THE MEDICAL CENTER OF AURORA
WOUND CARE CENTER
1400 S. POTOMAC ST., SUITE #110 AURORA, CO 80012

City of Aurora Building Division
Reviewed for Code Compliance
Approved as Noted: *J Eckert*
Date: *Oct 30, 2013*
2009 INTERNATIONAL CODES & 2011 NEC

RSN: *848551*
Permit #: *2013-794562*

LIFE SAFETY PLAN
SCALE: NTS

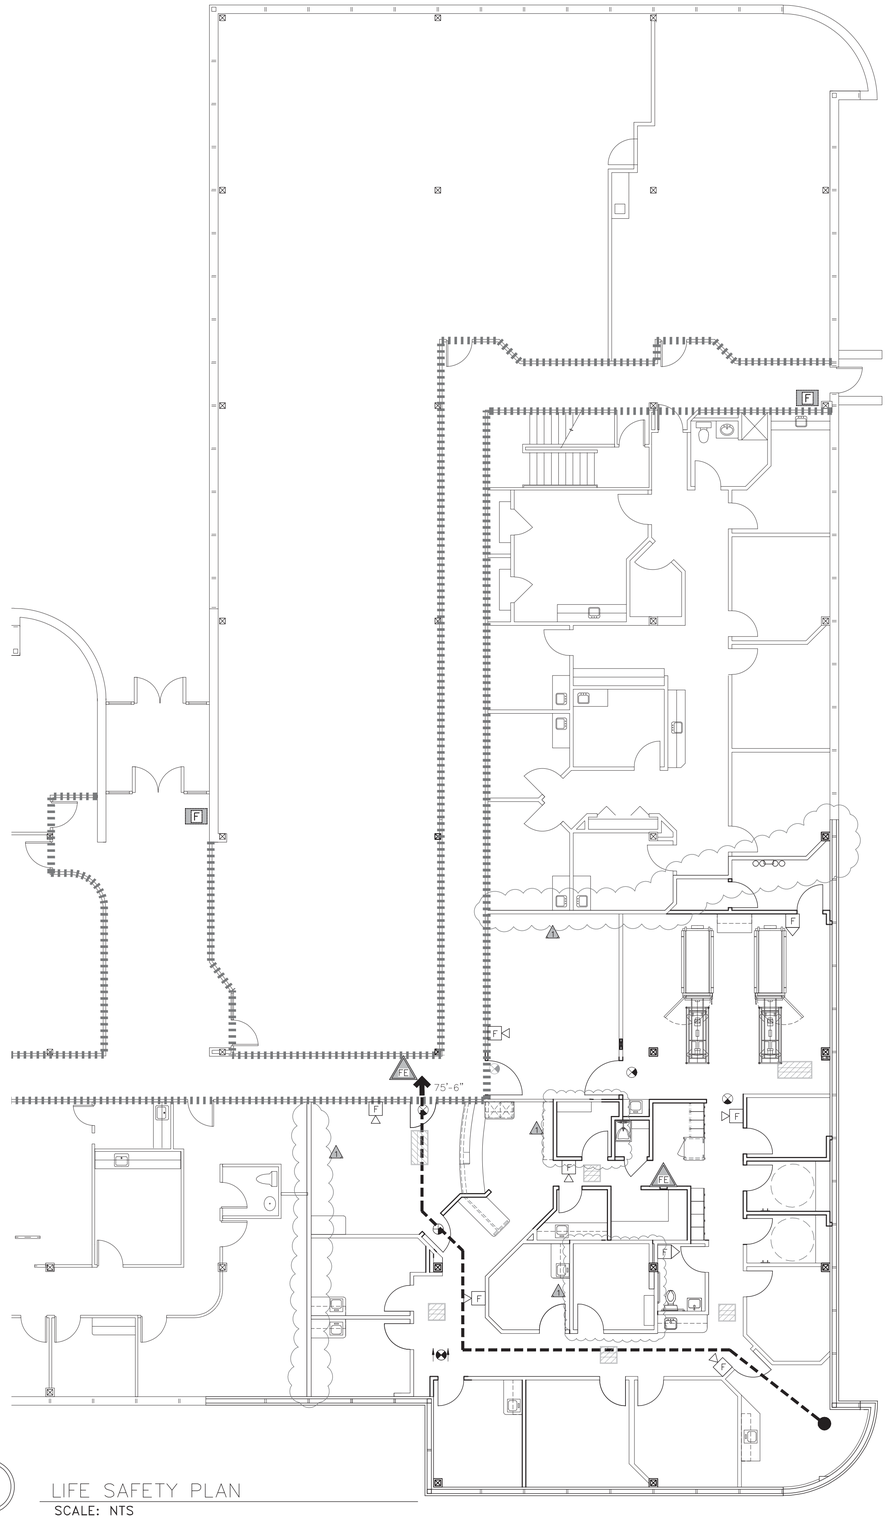
Provide a tactile sign saying "**EXIT**" at each egress stairway, exit passageway or exit discharge **2009 IBC 1011.3 and 2003 ANSI A117.1**

3 A4.2 P.O.U. 23
SCALE: 1/2" = 1

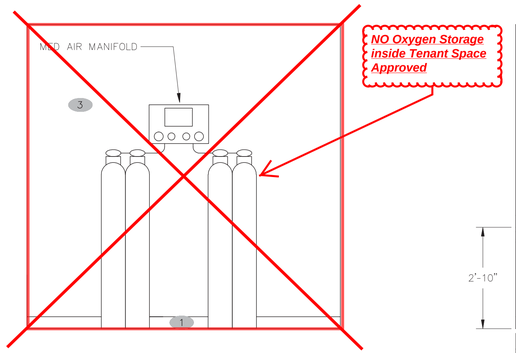
NO Oxygen Storage inside Tenant Space Approved

7 A4.2 CHAMBER HEADWALL DETAIL
SCALE: NTS

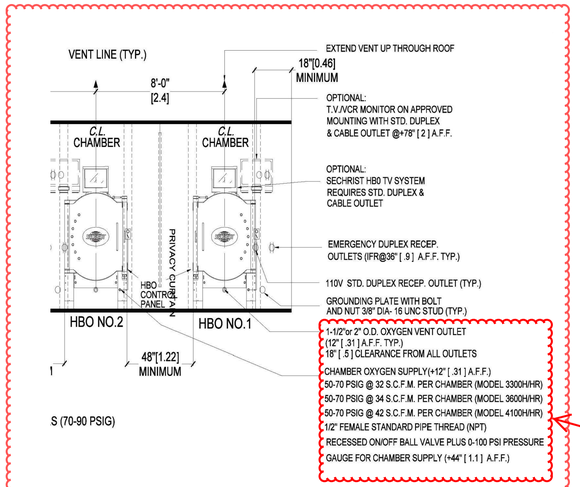
NO Oxygen Storage Inside Tenant Space Approved

ELECTRICAL LIGHTING NEW WORK PLAN

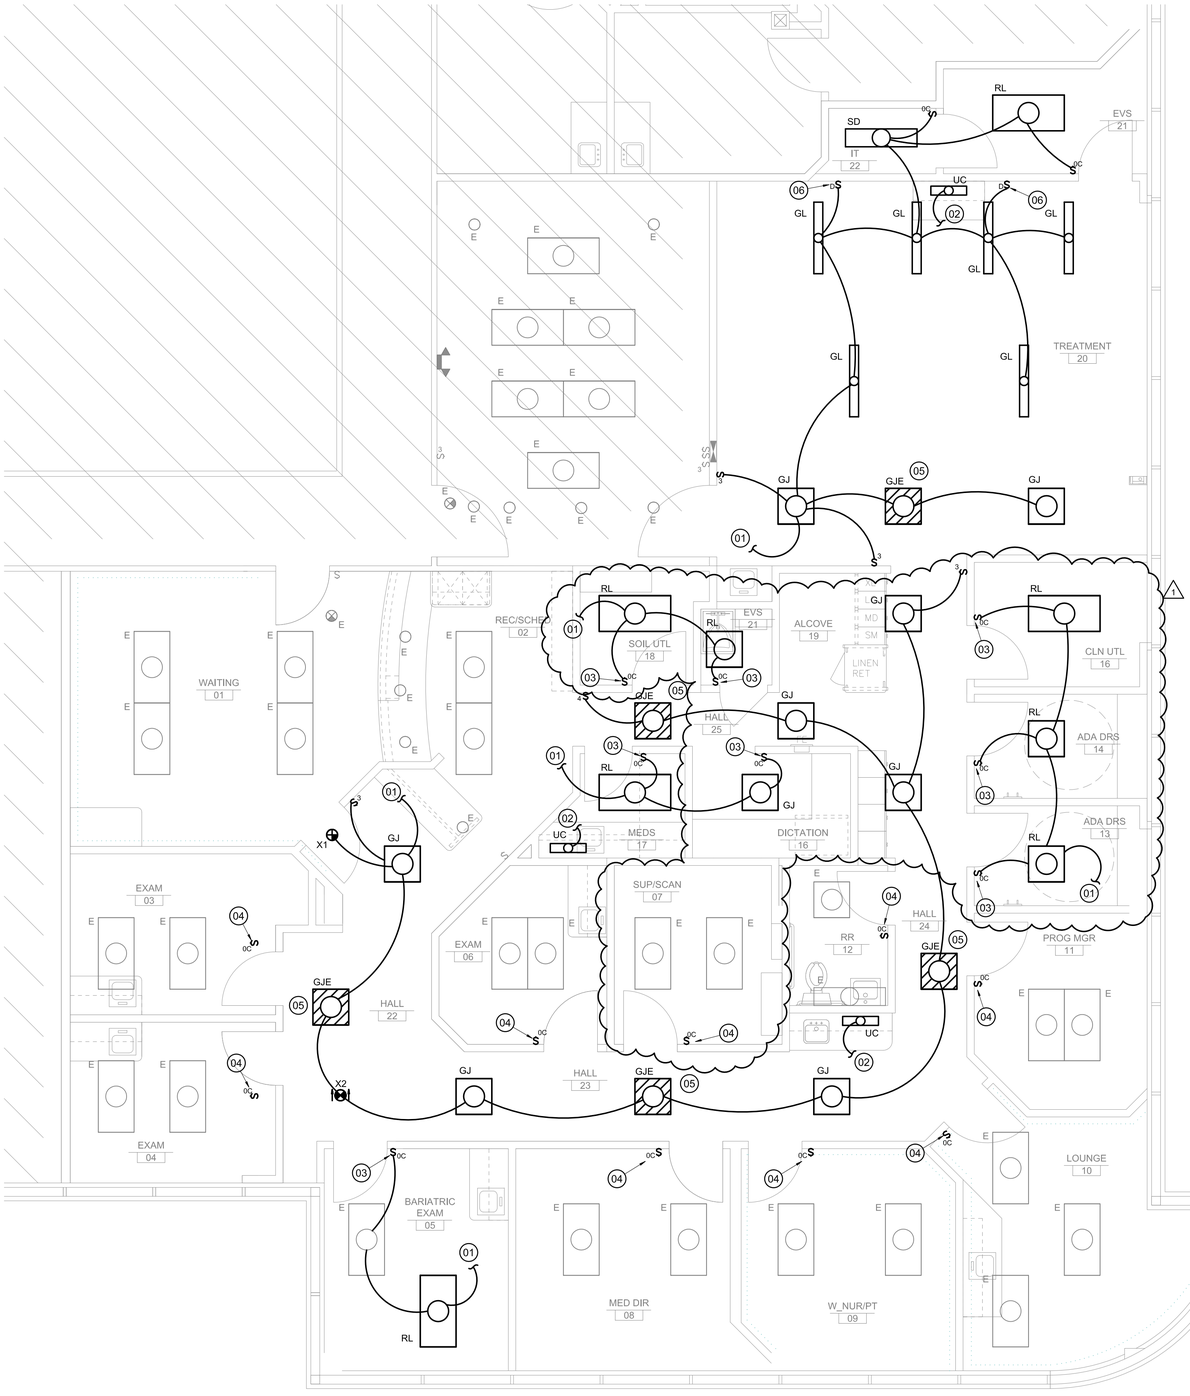
Provide emergency illumination equipment that complies with **2011 NEC 700.12 (F) or 2011 NEC 700.**

Install electrical connections **per 2011 NEC 110.14,** identify disconnects **per 2011 NEC 110.22** and provide working space around electrical equipment **per 2011 NEC 110.26**

SHEET TITLE:
POWER NEW WORK

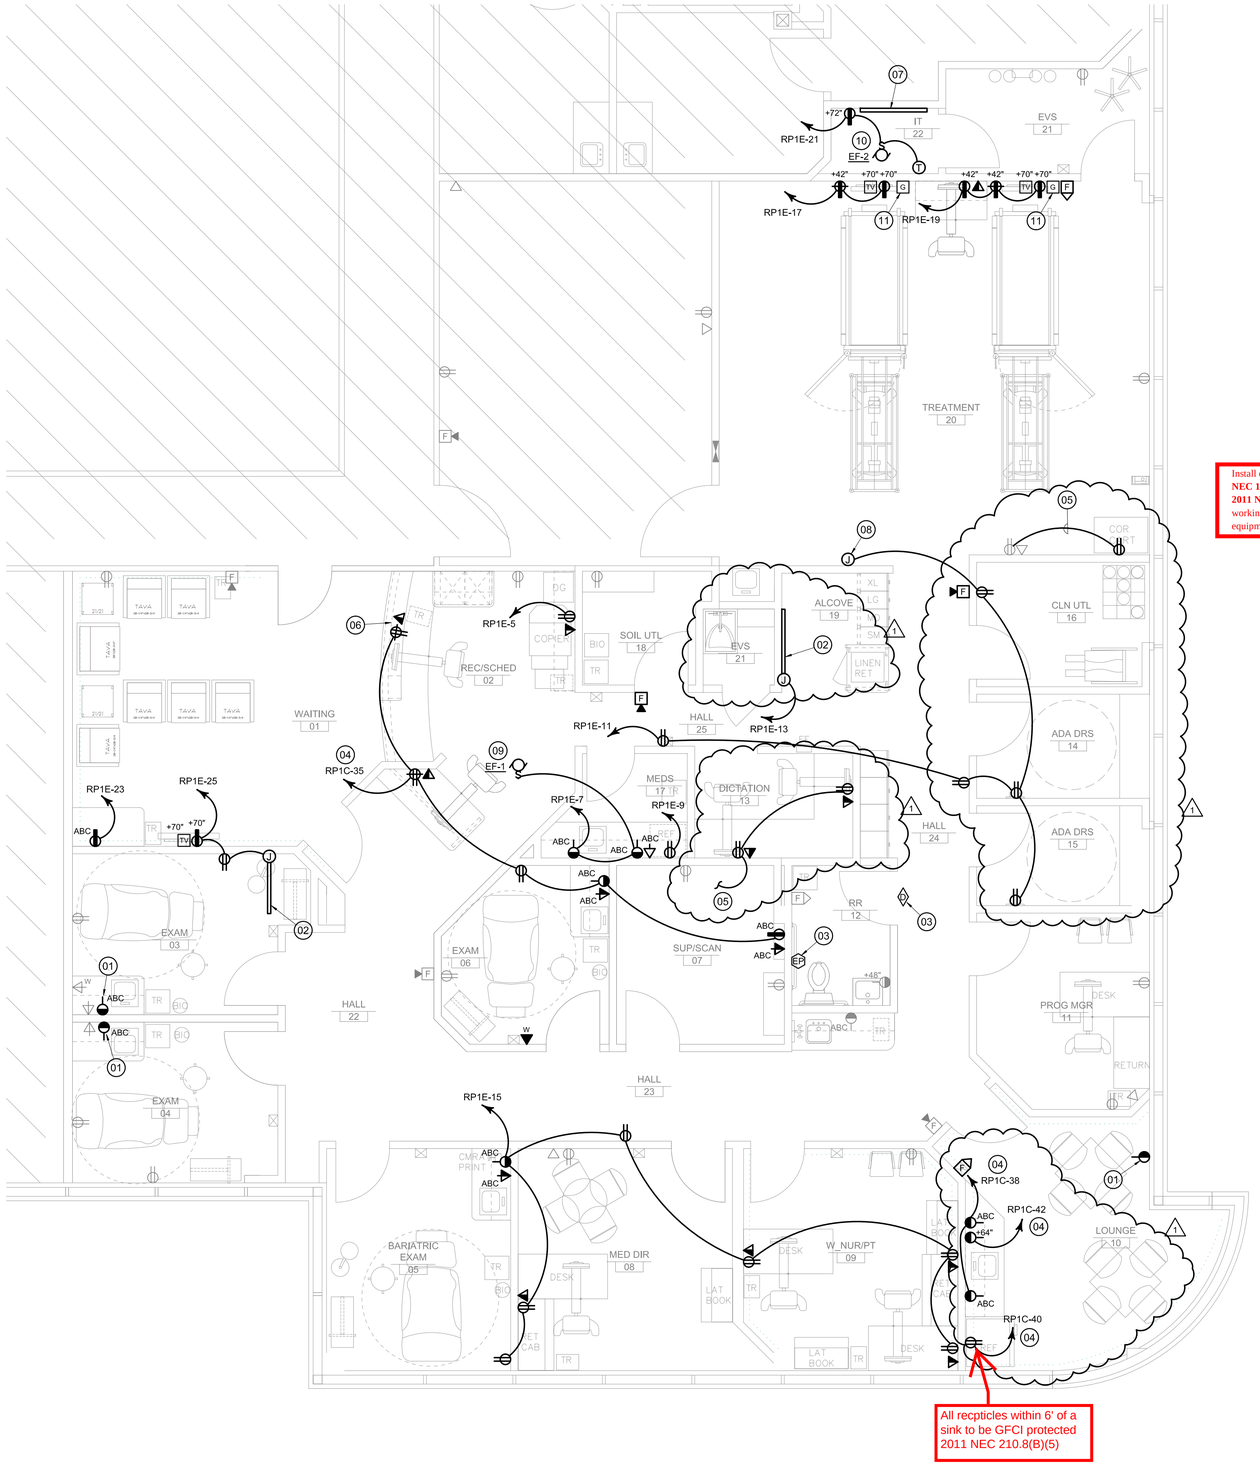
Install electrical connections **per 2011 NEC 110.14,** identify disconnects **per 2011 NEC 110.22** and provide working space around electrical equipment **per 2011 NEC 110.26**

SHEET TITLE:
MECHANICAL NEW WORK PLAN

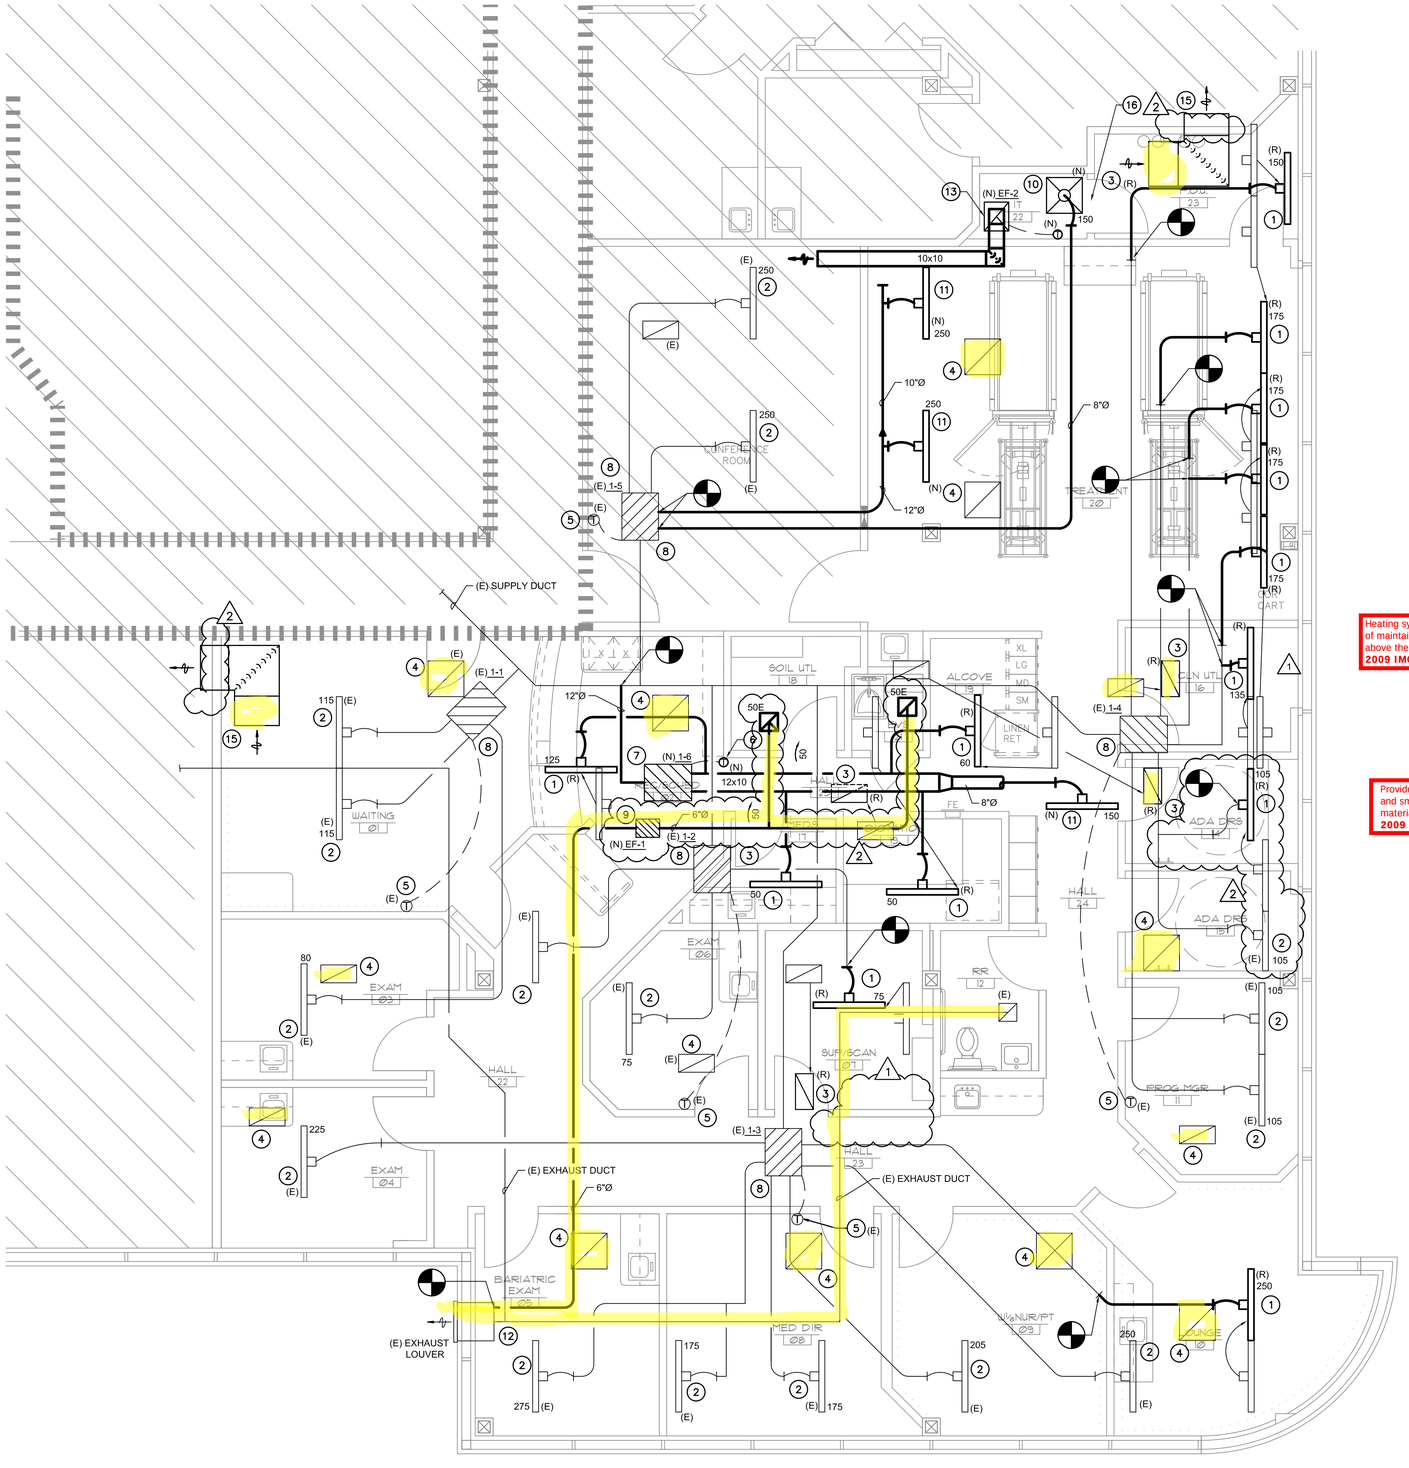
Heating system shall be capable of maintaining 68 degrees F at 3'-0" above the floor.
2009 IMC 309, IBC 1204.1, IRC R303.8

Provide proof of a flame spread <26 and smoke development <51 for any materials used within a plenum.
2009 IMC 602.2.1
